**TECHNICAL STAFF REPORT**  
**EMERSON**  
**Planning Board Meeting of May 8, 2008**

**File No./Petitioner:** SDP- 08- 37, Miller and Smith Homes, Inc.

**Project Name:** Emerson, Section 2, Phase 3, Lots 1 thru 45, SFA Dwelling Units

**LANDSCAPE PLAN**

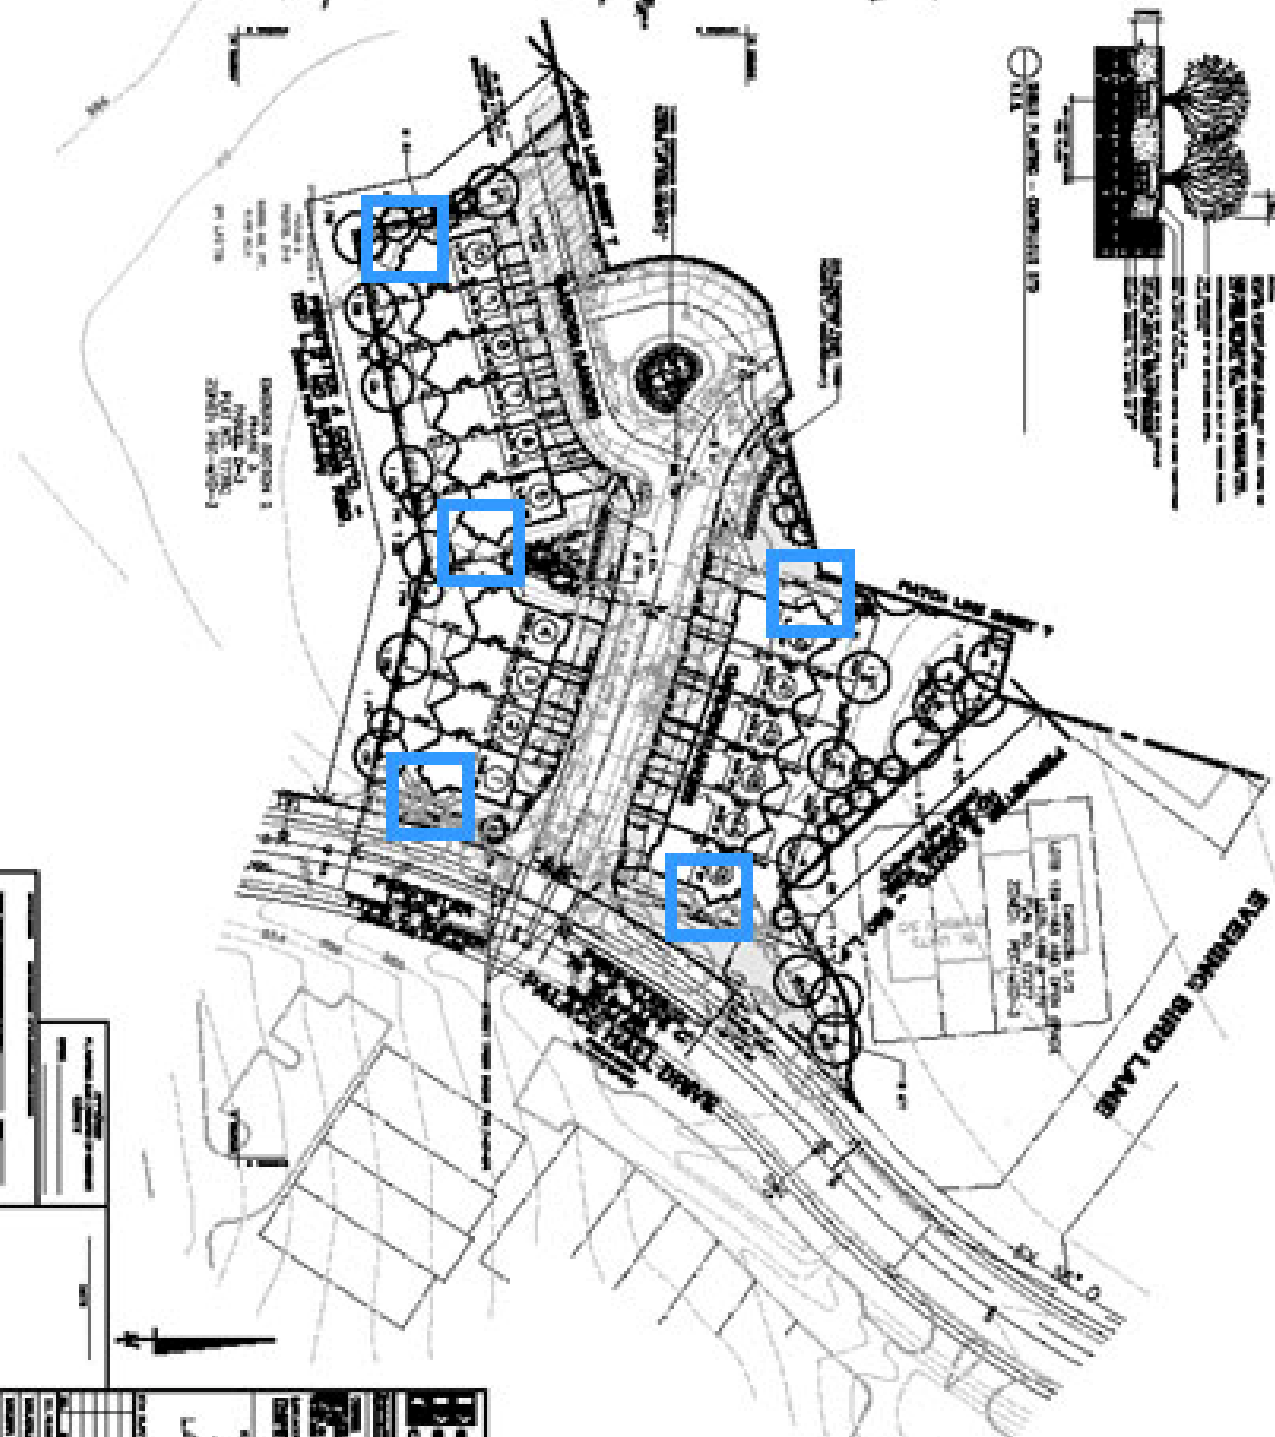
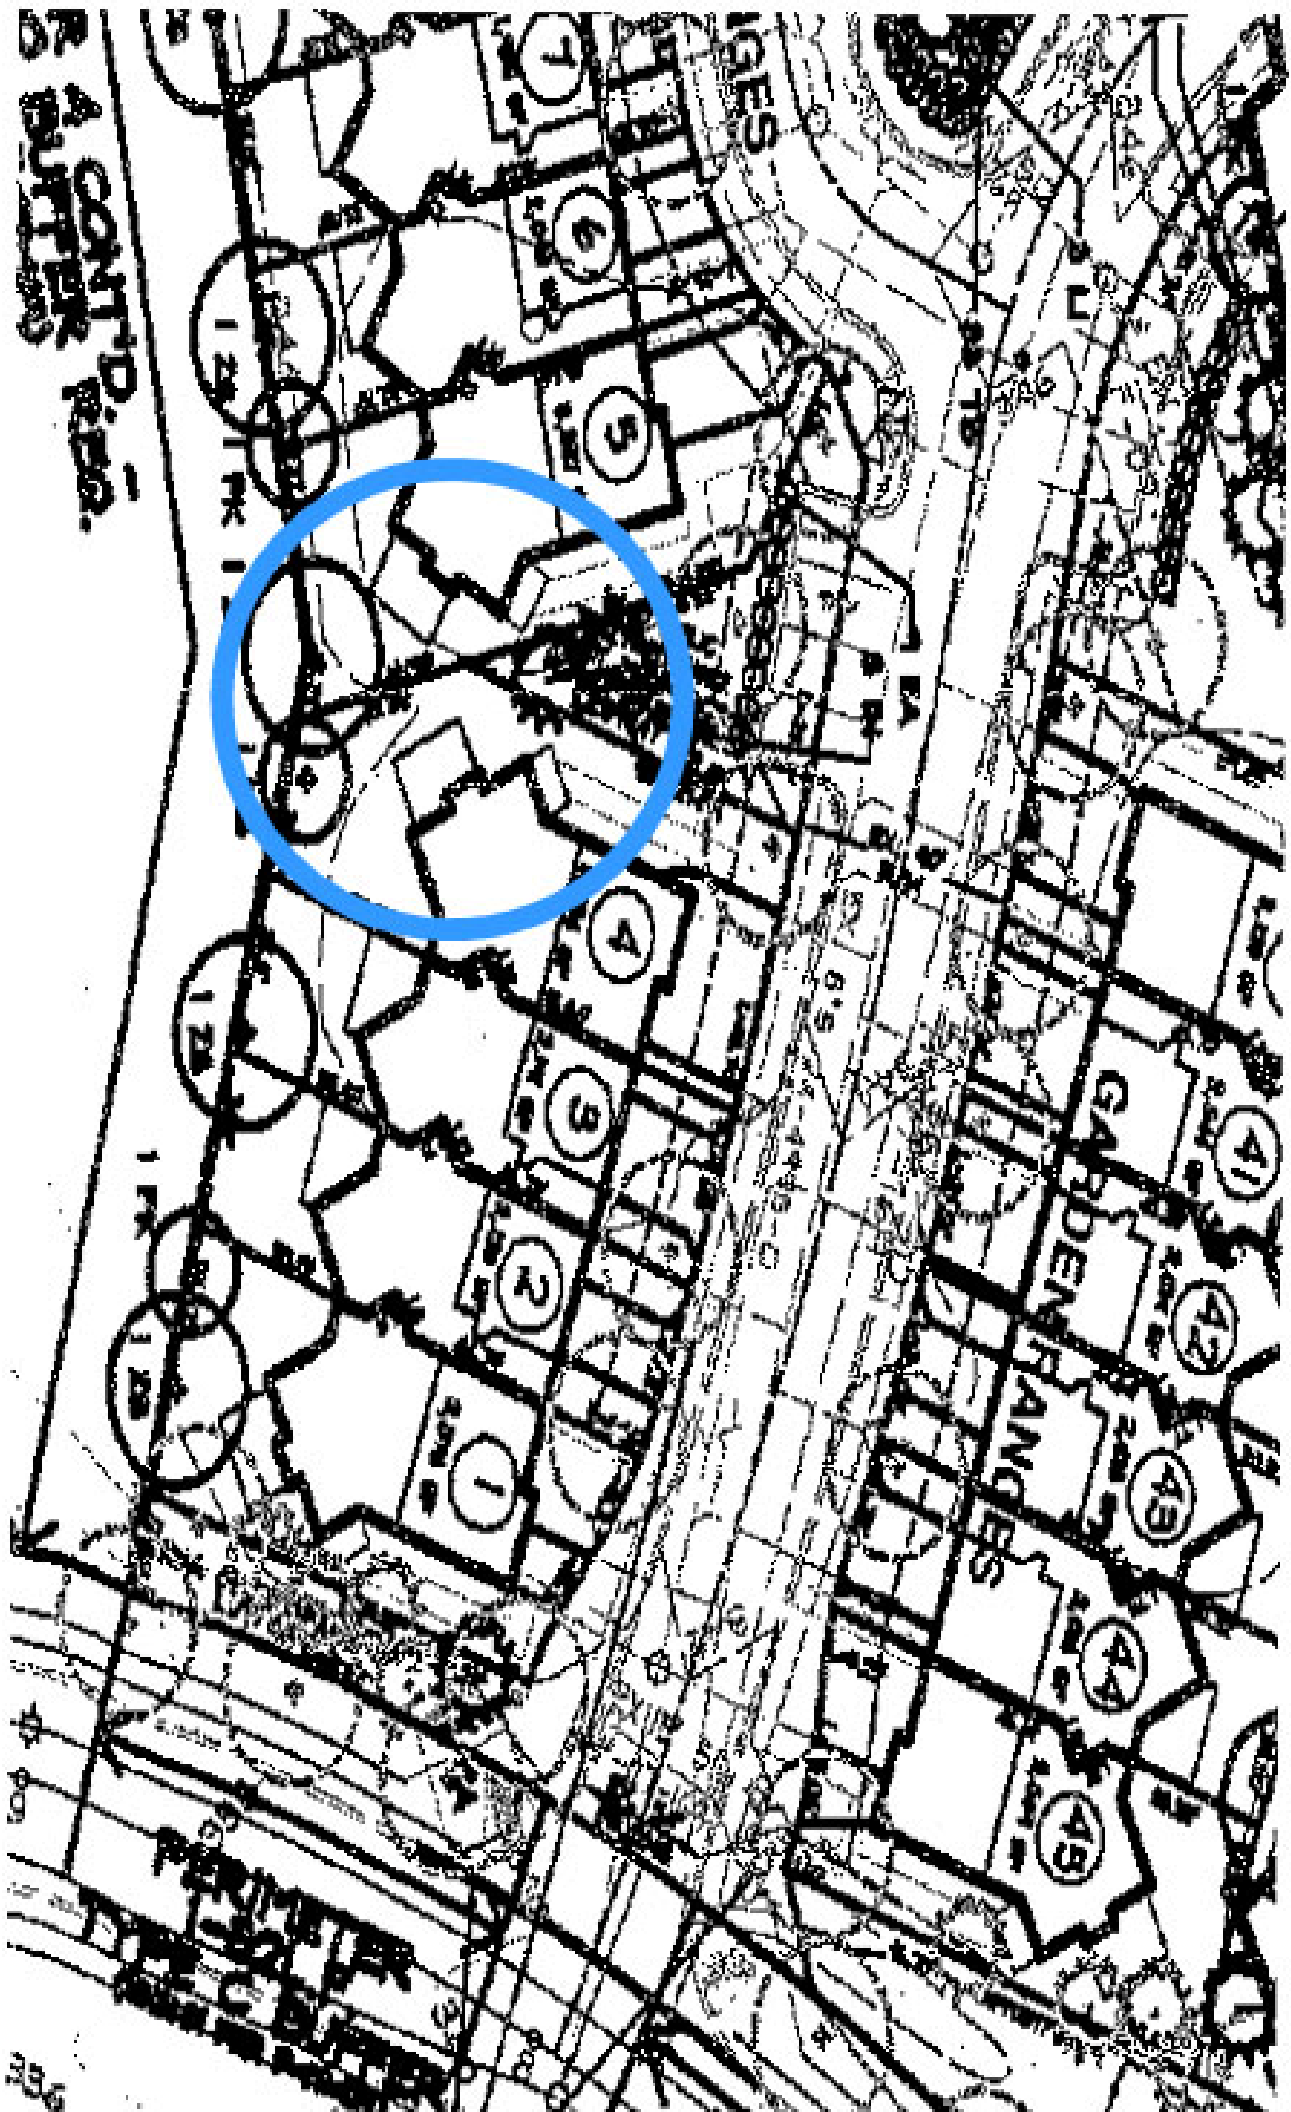
1. On the Final Site Plan Submission, please show the required min 2' building offsets at the front building elevations to provide articulation and visual relief.
2. Provide slight +/- 2' high mounds in the Street Islands.

1. On the Final Plans please show how any exposed utilities are to be screened.
2. Please submit shrub foundation plantings for each unit.
3. To the extent possible, consider introducing a few flowering trees into the streetscape.
